Designing 5V Tolerant PRISM® PCMCIA Radio Cards

Application Note

AN9980.1

FIGURE 2. CHANGES TO ISL37101P PRISM 3 PCMCIA RADIO

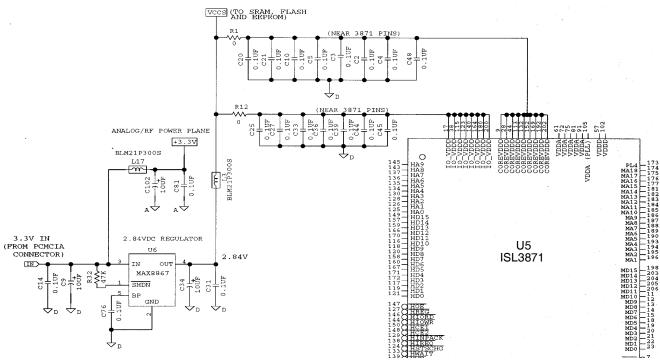
As noted in the *General* section above, a MAXIM MAX8867EUK29 (or MAX8867EZK29) 2.84V LDO Voltage

Regulator, U6, was added in series with the power bus supplying the IO_VDDD and COREVDDD pins to the ISL3871 COMBO Chip (U5) as well as the Vcc pins to the SRAM (U1), FLASH (U2) and EEPROM (U9) memories. The EZK regulator is a lower profile version of the EUK device and they are otherwise identical. The complete reference design is available on Intersil's Premier Web site. These devices are all rated for operation down to 2.7 VDC so no effect on radio performance occurs. The analog voltage pins to the ISL3871 chip are fed from the regulated VCCA 2.84V bus on previous ISL37101P designs so no change is necessary here.

FIGURE 4. CHANGES TO ISL37300P PRISM 2.5 PCMCIA RADIO

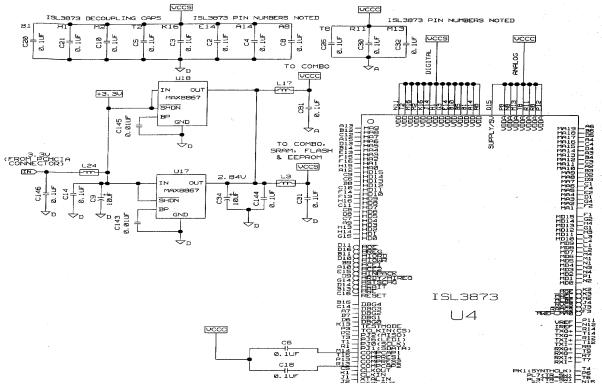
A change similar to that noted in the radio above was added here. However, since the LDO regulator must support the additional current drawn by the analog section of the ISL3873 Combo chip, U4 (approximately 30ma), a single MAX8867 regulator was not deemed adequate. Note that the LDO must deliver a minimum of 2.7 VDC to the Combo chip and memories, even at the low end of the input supply rail specification, 3.0V.

The problem was solved by employing two MAX8867EUK29 or MAX8867EZK29 regulators with their inputs and outputs connected in parallel. These regulators utilize a P-Channel MOSFET for the pass element. Under lightly loaded conditions, the regulator with the highest regulator voltage will be active. The pass element of the other regulator will be biased off by virtue of the analog voltage comparator in this unit sensing that the output voltage is too high compared to its internal voltage reference. As the current drain increases however, the output voltage of the active regulator will begin to slightly fall and a point will eventually be reached at which the second regulator will begin to supply significant output current. The EZK regulator is a lower profile version of the EUK device and they are otherwise identical.

The net effect of using two parallel LDO regulators is to essentially double the output current available at a particular differential voltage drop. This provides more than adequate drive capability.

FIGURE 5. CHANGES TO THE HWB3163 PRISM II PCMCIA RADIO

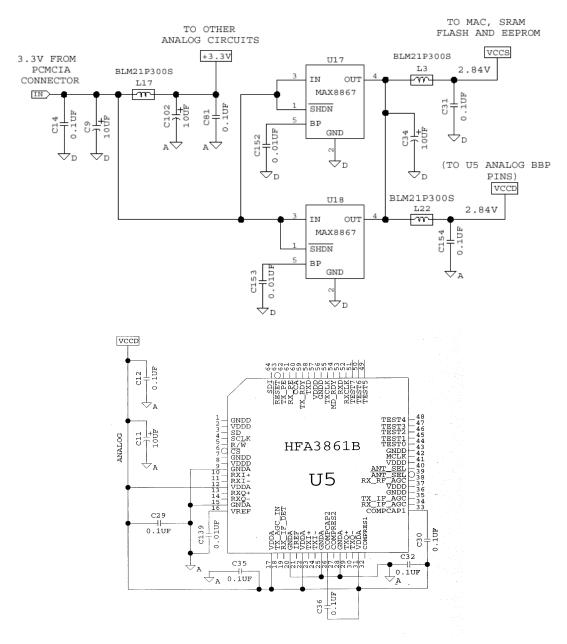
The 5V tolerant modifications to this radio are basically the same as that applied to the ISL37300P radio above with the exception that this older design uses separate BBP and MAC IC's instead of a Combo chip.

Once again, the voltage feed to the MAC, FLASH, SRAM and digital pins of the BBP, i.e. the entire VCCS power bus is

fed from the output of the paralleled MAX8867EUK29 (or MAX8867EZK29) LDO regulators. Additionally, the voltage for the analog pins of the BBP, formerly fed from the 3.3V bus is now fed from a new 2.84V bus labeled VCCD on the diagram in Figure 5 (next page). VCCD is derived from the output of the LDO regulator through separate decoupling components in order to properly isolate the analog and digital power buses.
